METRO PLANNING COMMITTEE OF THE TOWN PLANNING BOARD

MPC Paper No. 3/19

**Submission for Compliance with
Approval Condition (j) of Application No. A/H4/94**

**Proposed Alteration and Modification Works to the Building
and External Façade for Cultural/Leisure/Retail/Food &
Beverage Uses/Open Space/Ancillary Support, for the Central Market
Revitalization Project in “Other Specified Uses” annotated
“Building with Historical and Architectural Interests Preserved for
Commercial, Cultural and/or Community Uses” Zone,
The Former Central Market, 80 Des Voeux Road Central, Central, Hong Kong**

SECTION A PROPOSED TYPICAL TREE PIT (WITHOUT EXISTING RAILING) 1:30@A3

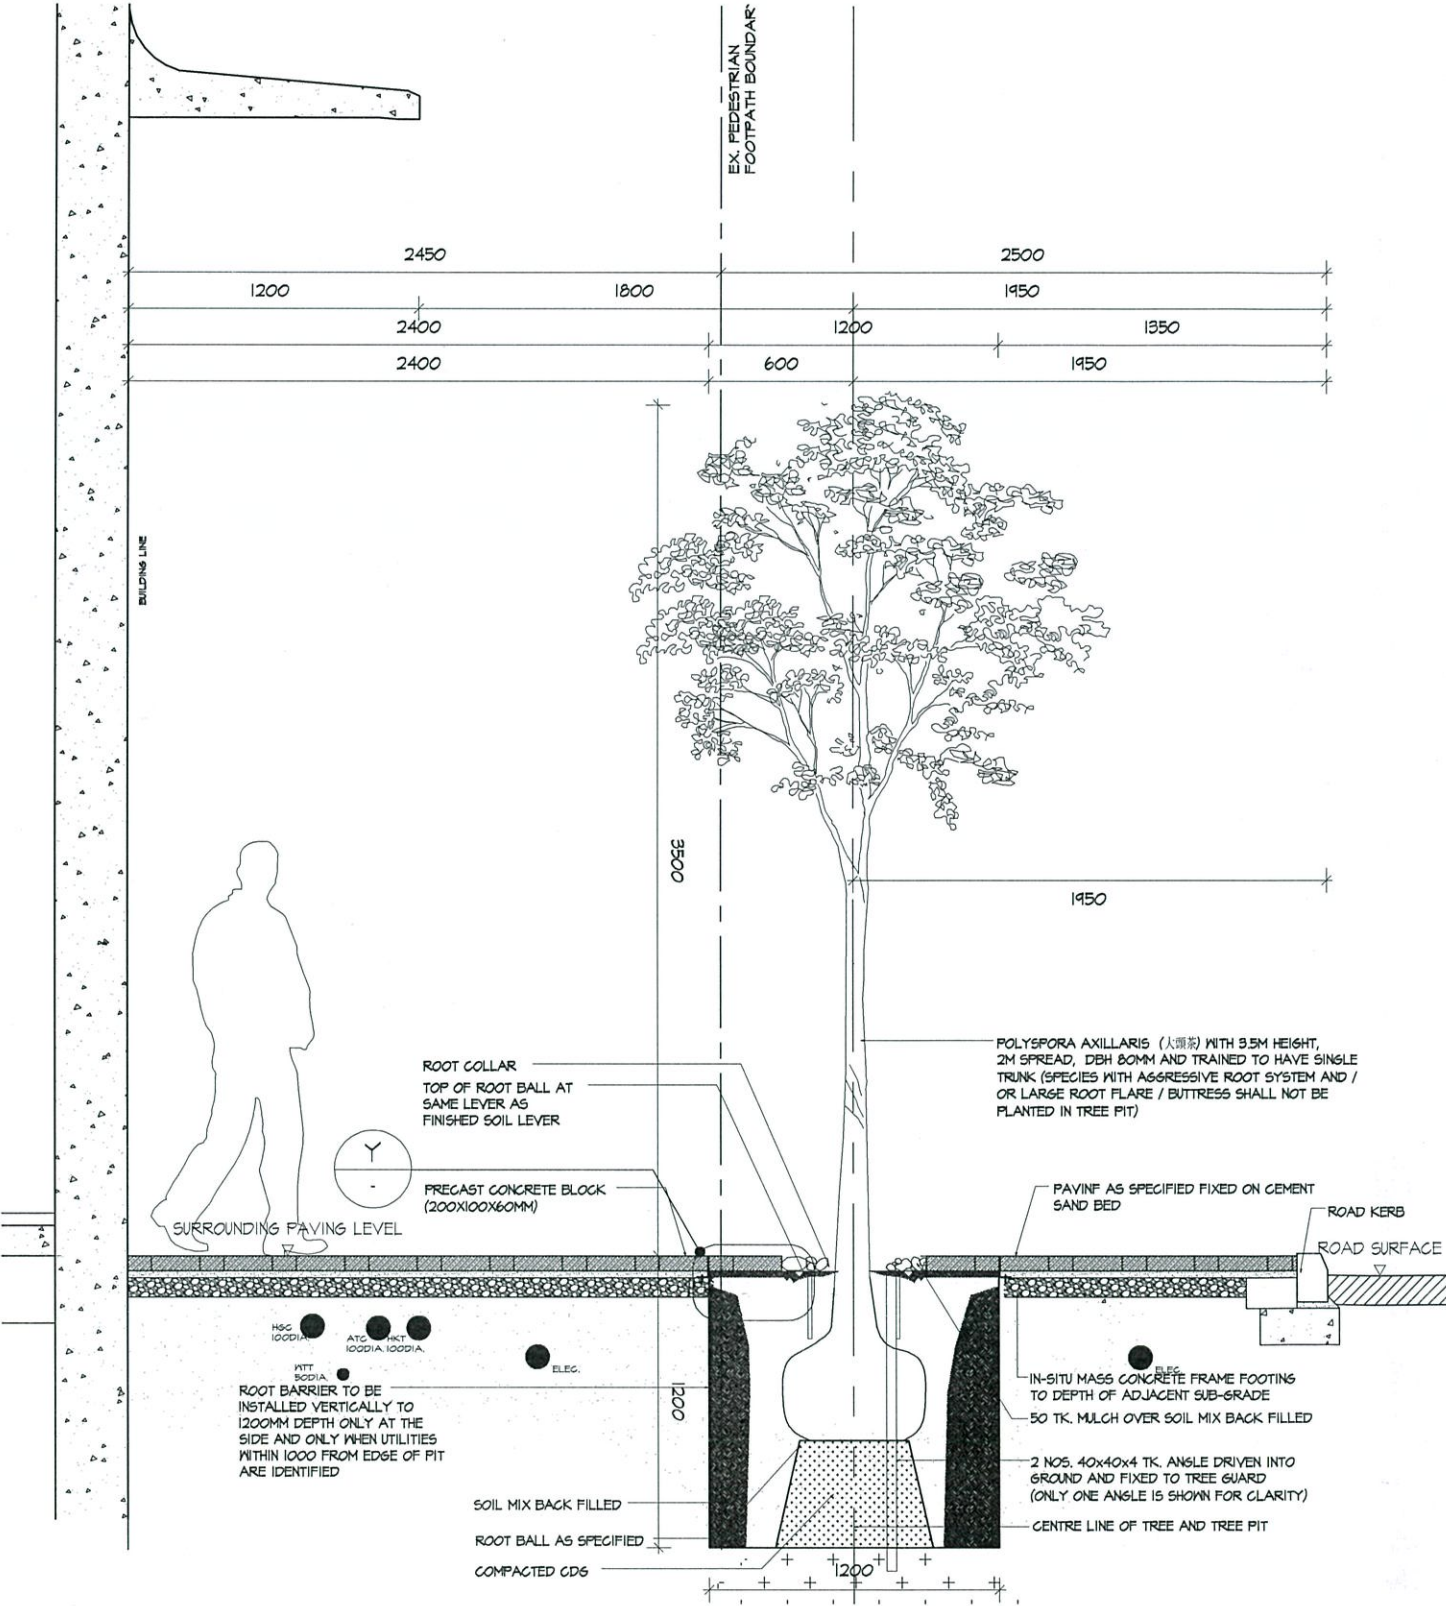
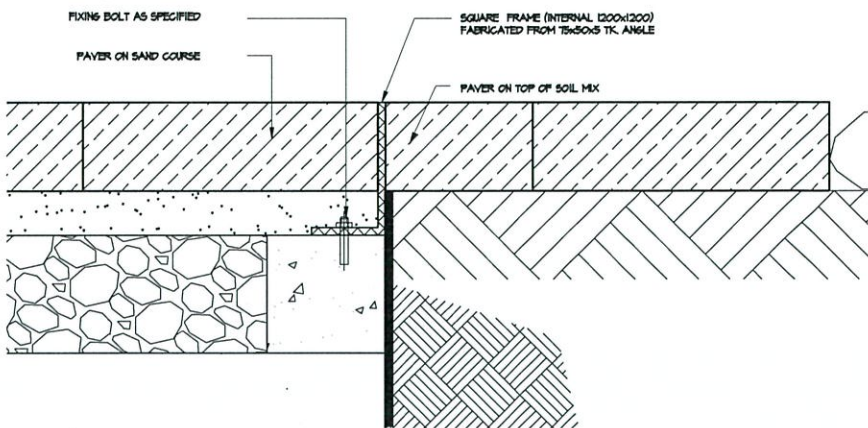
- (v) it is noted that *Polyspora axillaris* (大頭茶) will be planted on the footpath on Queen Victoria Street. The applicant should ensure the mature tree spread and tree roots would not adversely affect the proposed Grade 3 historic building; and

(v) The proposed tree pits should be constructed in accordance with highways standard drawings.	(v) Noted.
		(vi) All the associated traffic signs, road making, street furniture, lamp post and roadside gullies should be relocated in conjunction with your footpath widening proposal.	(vi) The relevant traffic signs / traffic lights/ road markings/ crossing lines to be provided and obsolete signs to be removed are shown on Figure 2.1 (rev.1) .
4	Commissioner for Transport (Contact Person: Mr. Ryan FUNG; Tel: 2829 5426)	<ol style="list-style-type: none"> 1. <i>Nil</i> 2. We have no comment on the footpath widening proposal from traffic engineering point of view, provided that 34m and 65m long lay-bys are maintained at Queen Victoria Street and Jubilee Street respectively. 	2. Noted
5	Antiquities and Monuments Office (Contact Person: Ms. Janny LUI; Tel: 3910 6632)	<ol style="list-style-type: none"> 1. <i>Nil</i> 2. The former Central Market is a proposed Grade 3 historic building. Please be informed that the Antiquities and monuments Office (“AMO”) has no objection in-principle on applicant’s submission for compliance with approval condition (j) cultural heritage conservation viewpoint, subject to the following conditions please:- 	2. Noted.

- 2.2.1 The portion at northern half of Queen Victoria Street pavement is proposed to be landscaped. 4 nos Polyspora axillaris (大頭茶) with 3.5m height, 2m spread and DBH 80mm is proposed to be planted with 5m (centre to centre) spacing at the locations shown in **Figure 2.1** to enhance the street greening effect. Soil Volume is 1.2m x 1.2m x 1.2m minimum in accordance with Street Tree Selection Guide published by the Government and shown in **Figure 2.3**.

FIGURE 3.1

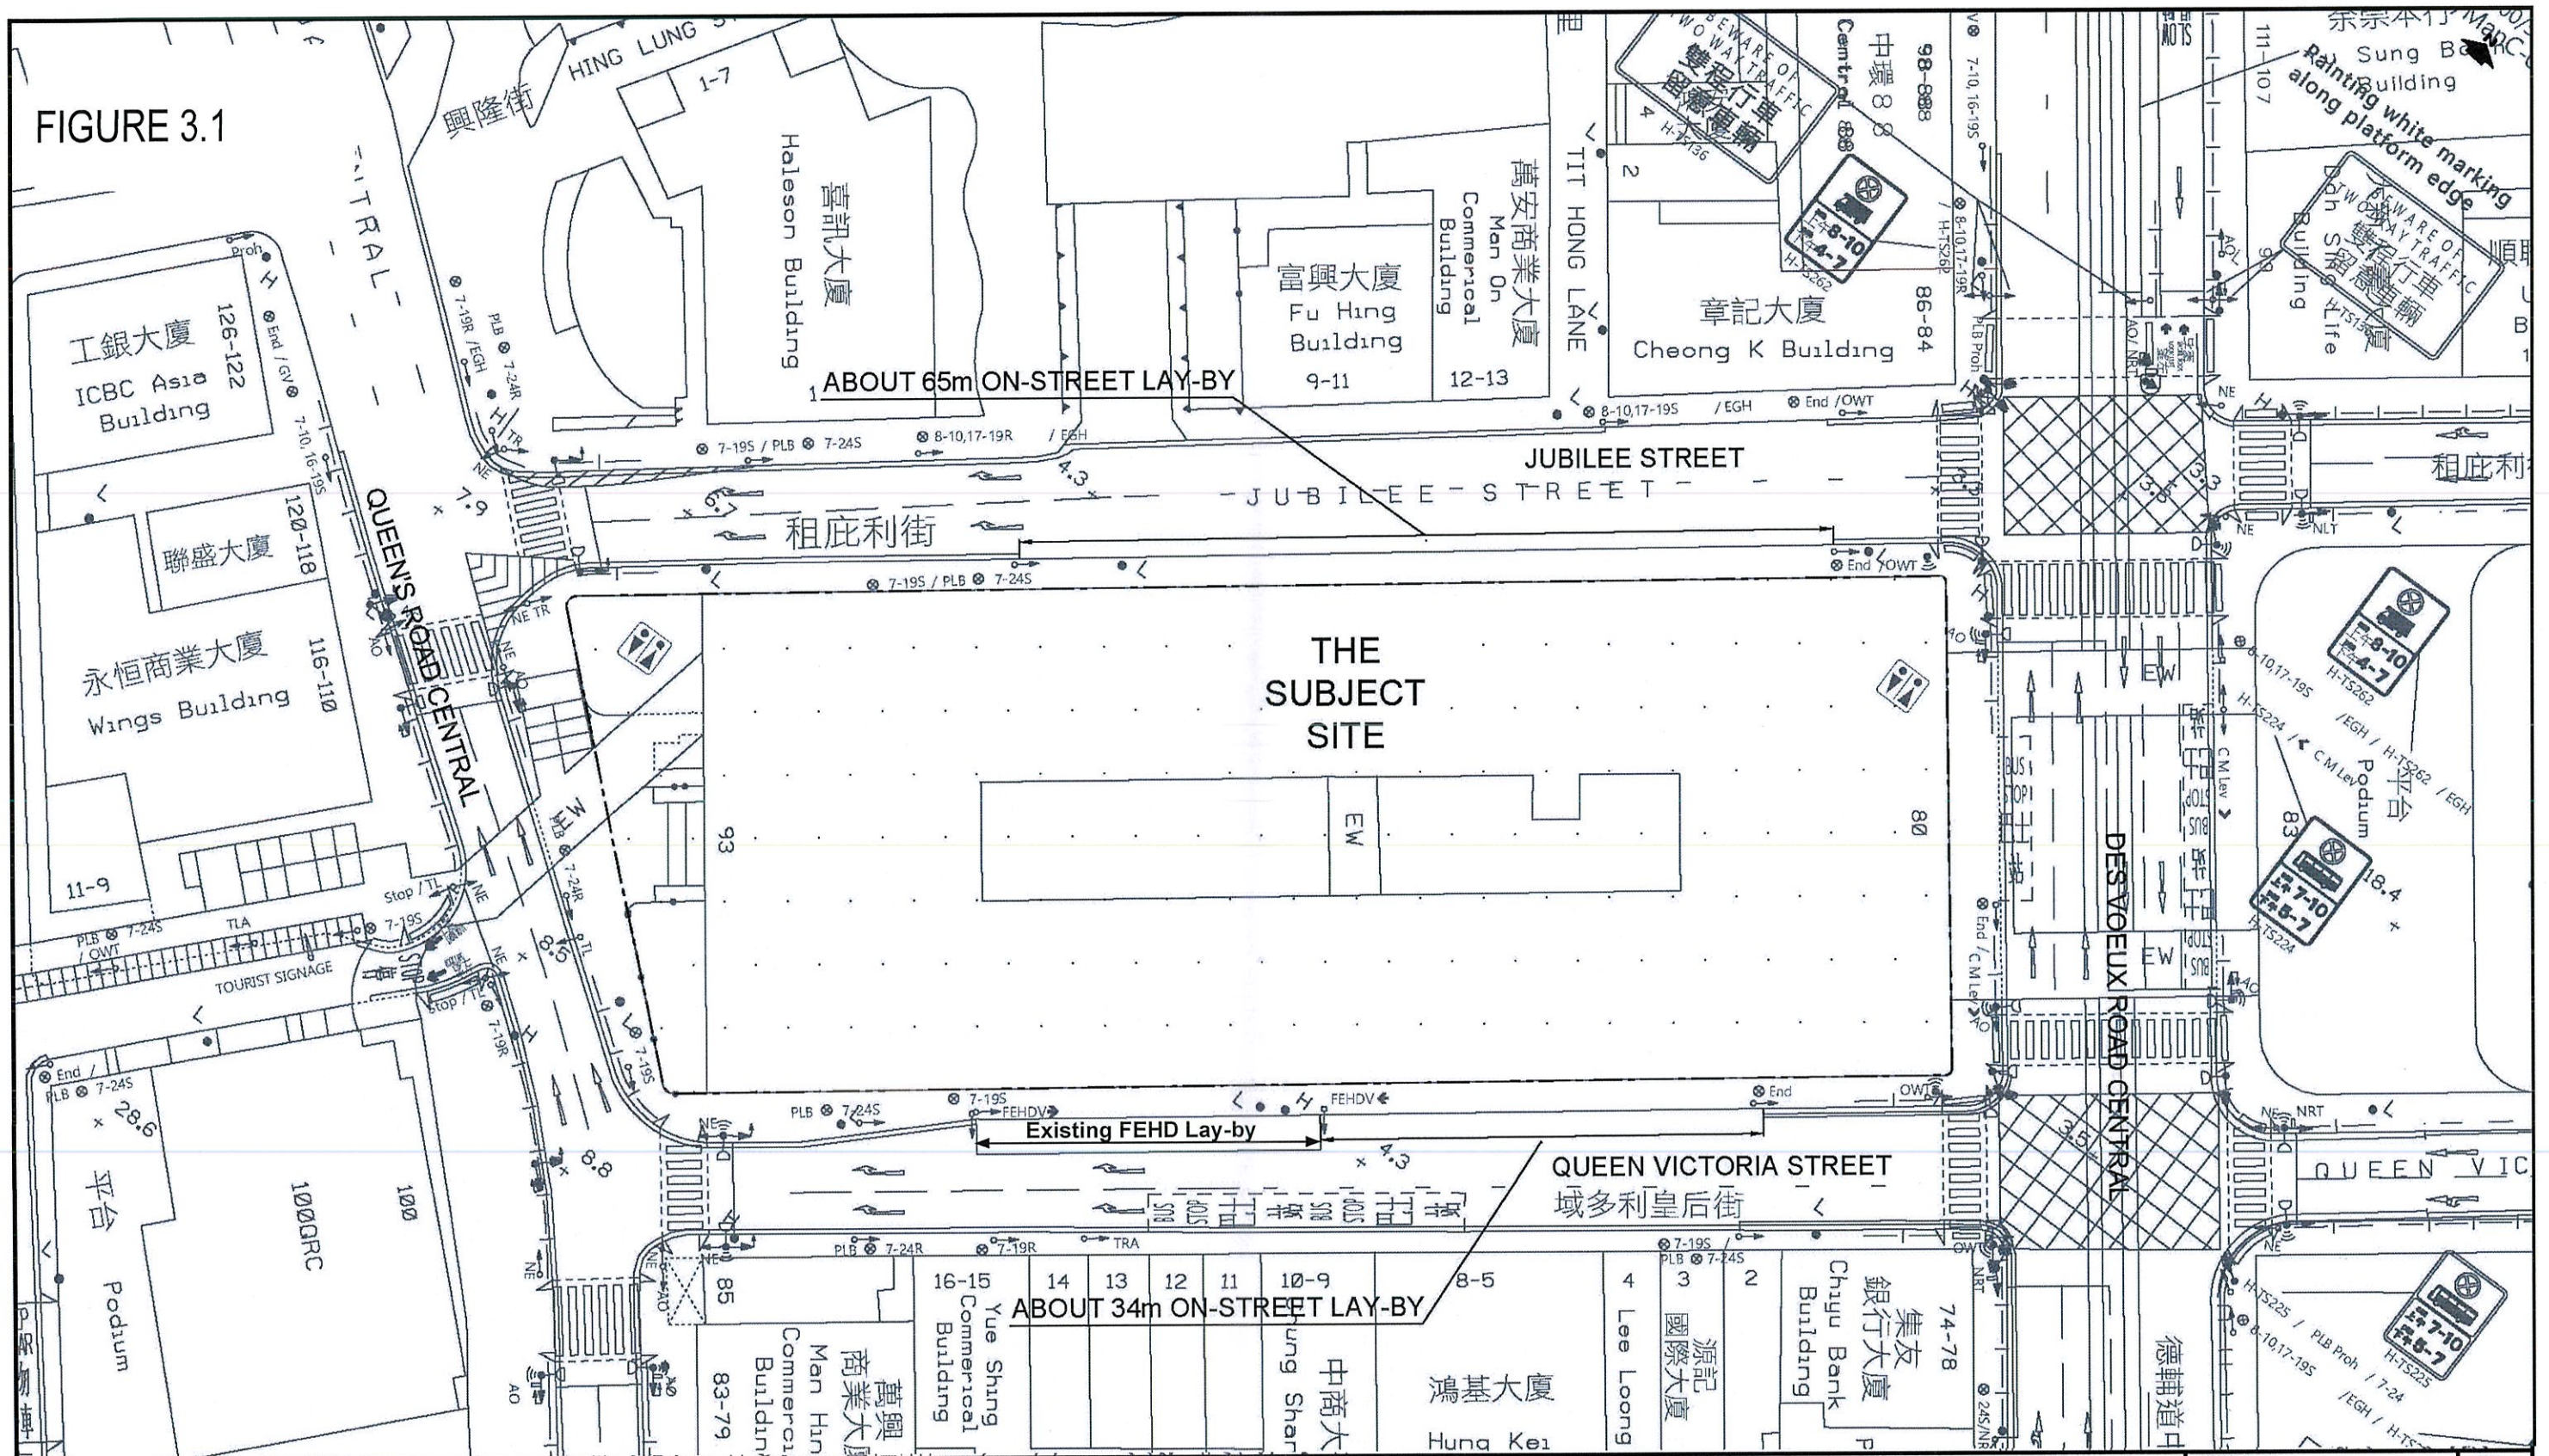
No comment on the footpath widening proposals from the traffic engineering point of view, provided that 34m and 65m long lay-bys are maintained at Queen Victoria Street and Jubilee Street respectively.

- 3.2.1 The current available length for on street L/UL activities at Jubilee Street and Queen Victoria Street are 65m and 34m respectively (refer to **Figure 3.1**).
- 3.2.2 After the implementation of the pavement widening proposal and the relocation of the existing FEHD lay-by at Queen Victoria Street, the available length of on street L/UL activities at Queen Victoria Street will be remained at 34m long. The available length at Jubilee Street will remain at 65m.
- 3.2.3 The L/UL activities for the Central Market shall be carried out at Queen Victoria Street and Jubilee Street and share with public as accepted in the S.16 planning application no. A/H4/94.
